DESCRIPTION	SHT. NO.
GENERAL LAYOUT	93
GENERAL NOTES	94-95
42" WATER MAIN PLAN AND PROFILE	96-100
24" WATER CONNECTION PLAN AND PROFILE	101
12" WATER CONNECTION PLAN AND PROFILE	102-103
CORROSION PROTECTION	104-109
WATER DETAILS	110-113

STATE OF HAWAII DEPARTMENT OF TRANSPORTATION HIGHWAYS DIVISION	
GENERAL LAYOUT	
KAHEKILI HIGHWAY WIDENING Likeli Hwy. to Vicinity of Haiku Road F.A. PROJECT NO. NH-083-1(26)	
SCALE: AS NOTED	DATE: APRIL 1994
SHEET No. WT1 OF WT21 SHEETS

STATE OF HAWAII DEPARTMENT OF TRANSPORTATION HIGHWAYS DIVISION	
GENERAL WATER NOTES	
KAHEKILI HIGHWAY WIDENING Likelike Hwy. to Vicinity of Haiku Road F.A. PROJECT NO. NH-083-1(26)	
SCALE: AS NOTED	DATE: APRIL 1994
SHEET No. WT2 OF WT21 SHEETS

PLAN AND PROFILE
42" WATER MAIN
W.L. STA. (-)1+85.97 TO 9+50

TYPICAL TRENCH RESTORATION DETAIL
Not to Scale

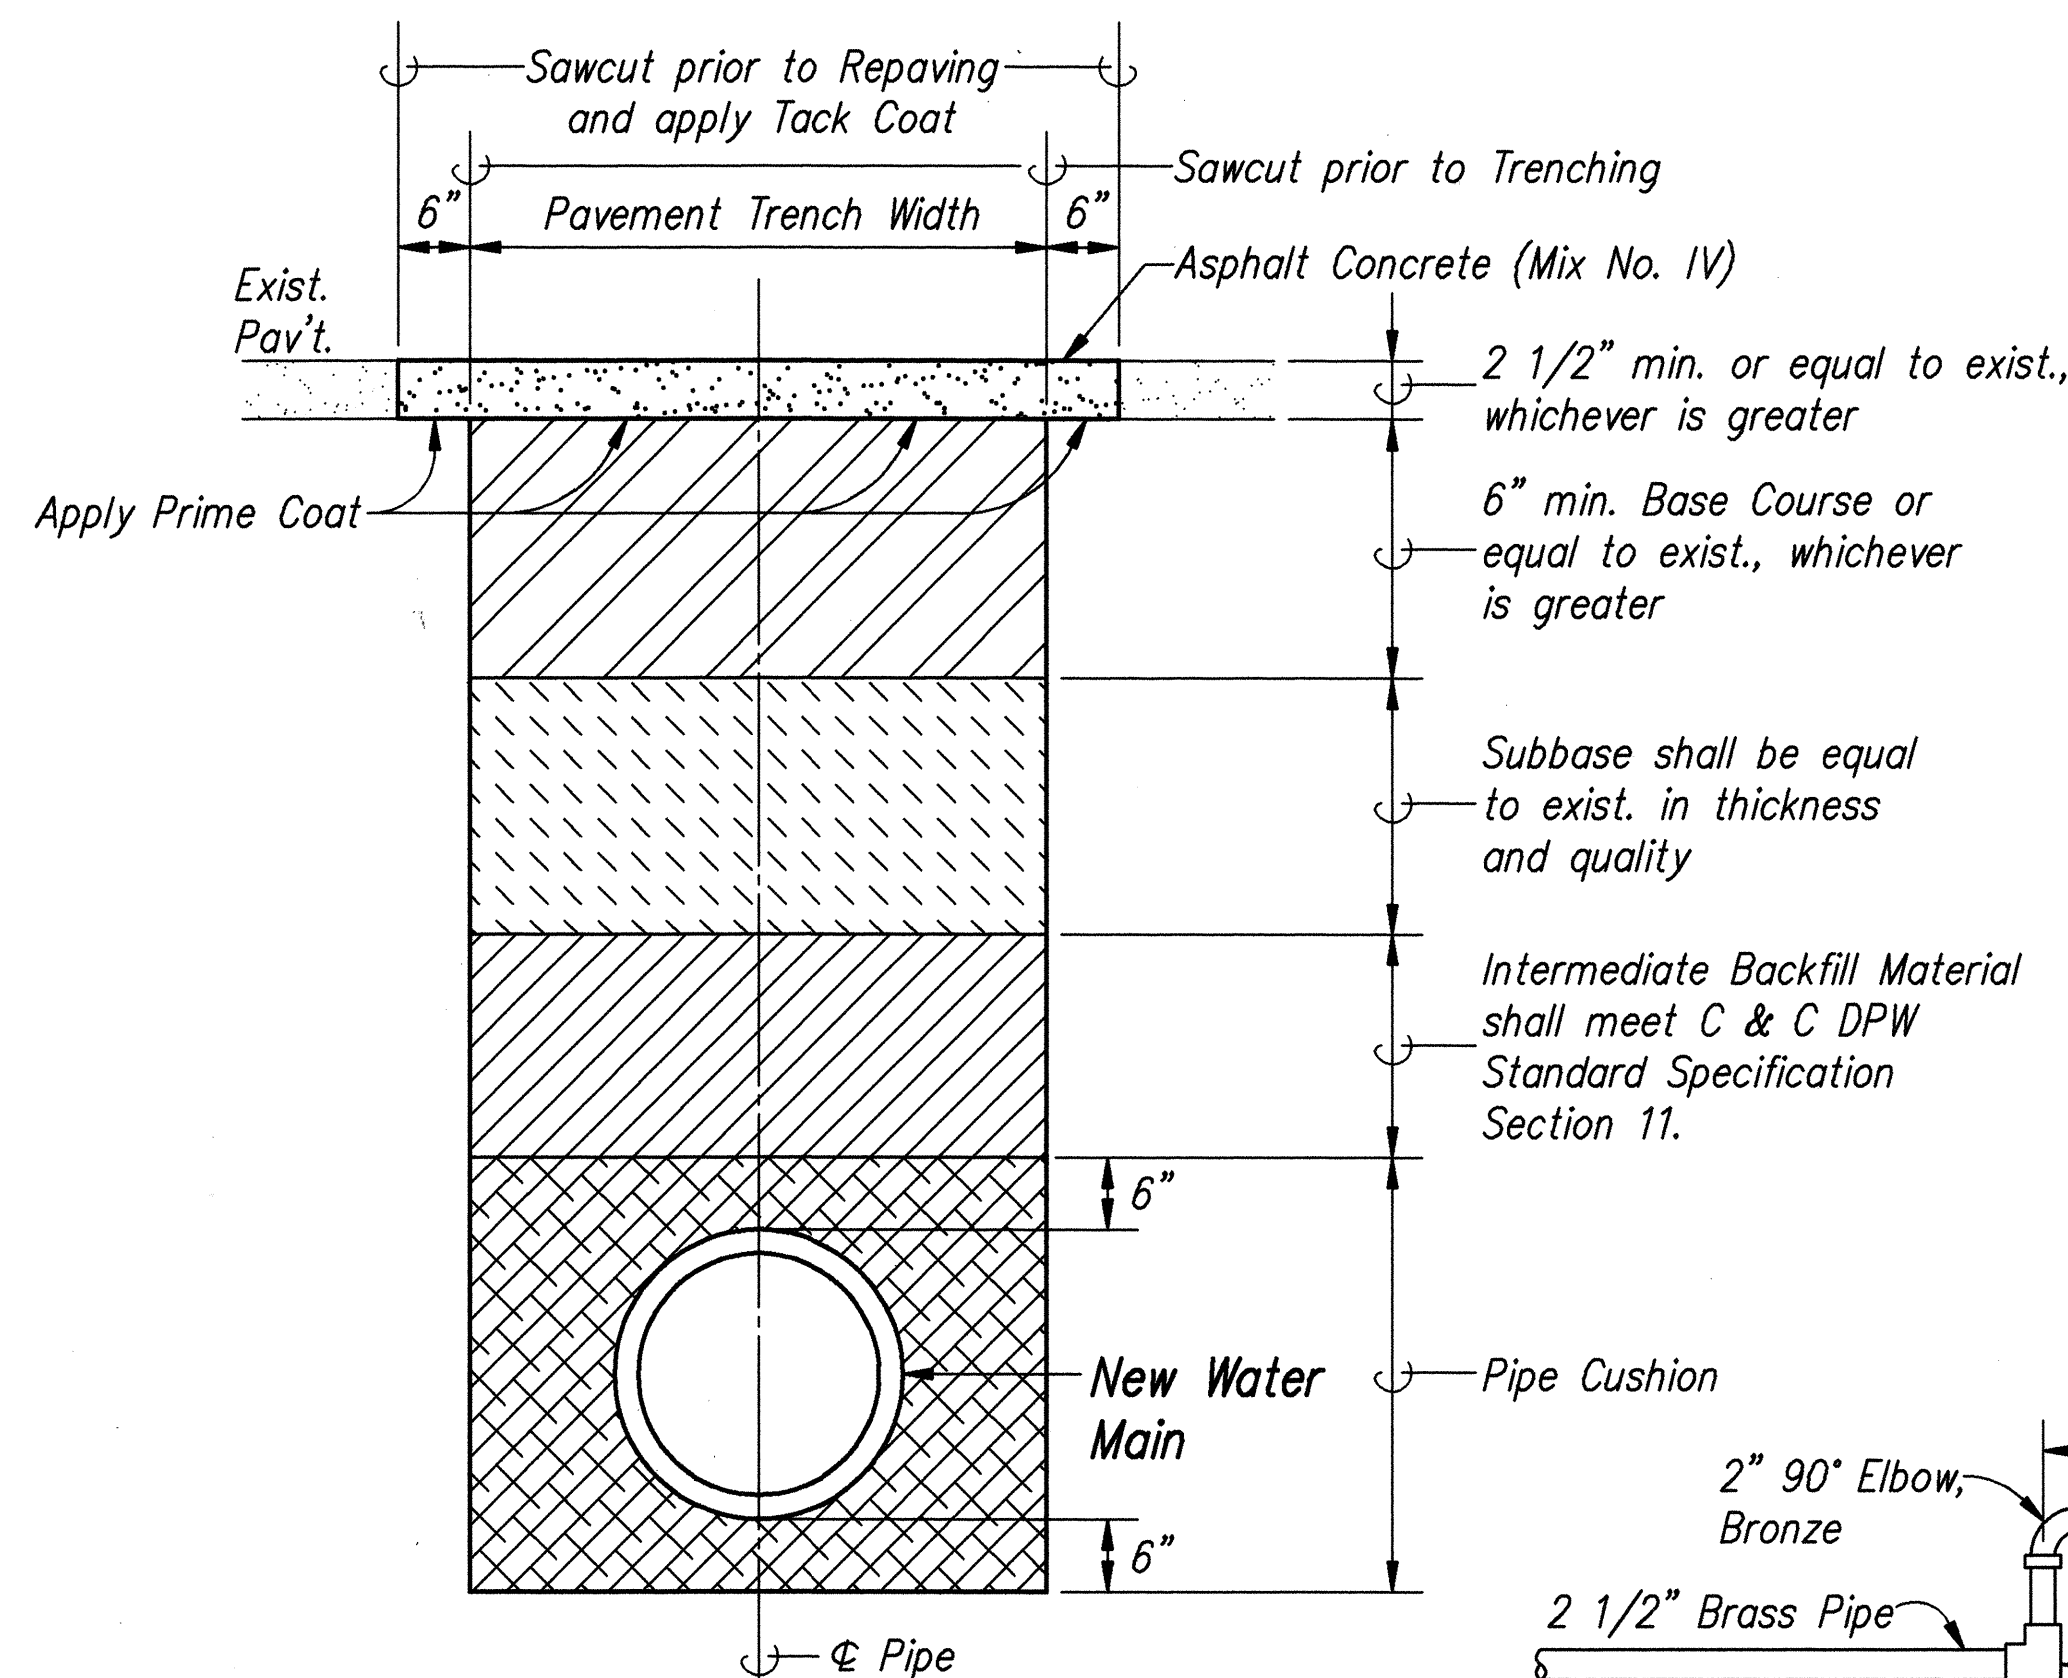
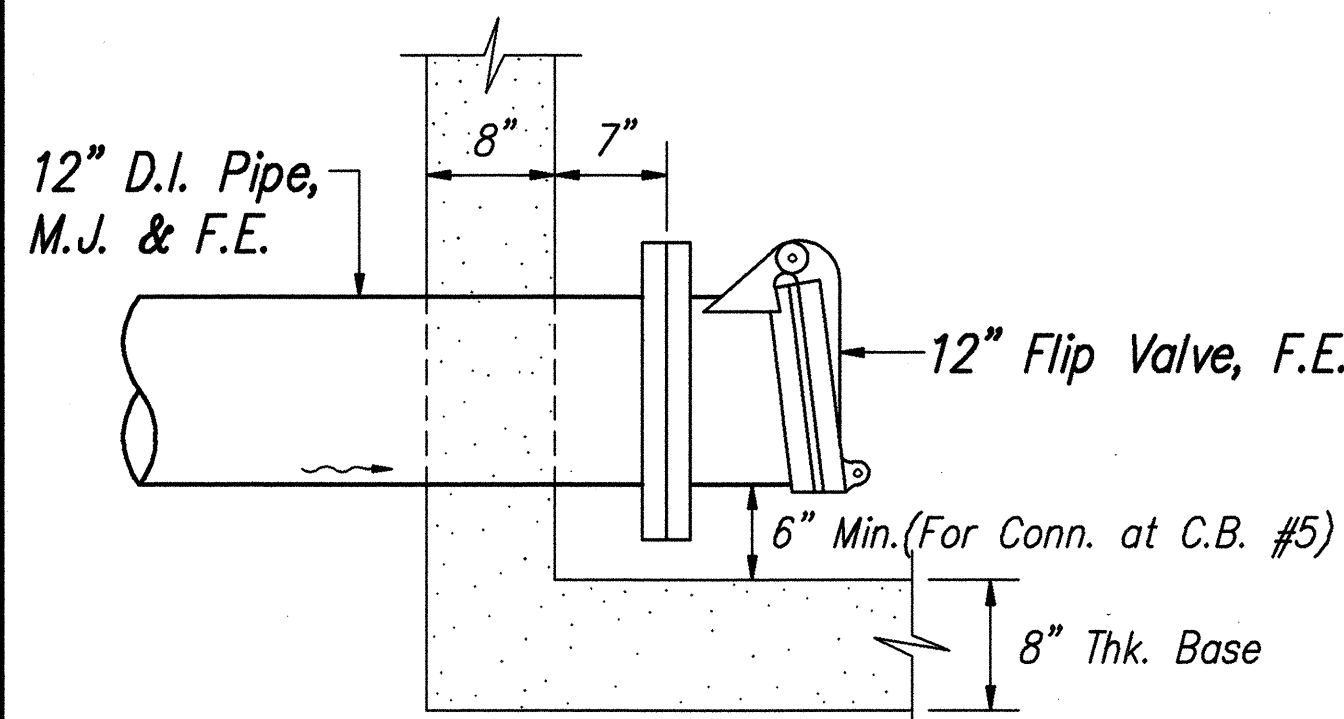
7/13/94	REVISED THICKNESS AND ADDED NOTE FOR TRENCH RESTORATION DETAIL.
DATE	REVISION
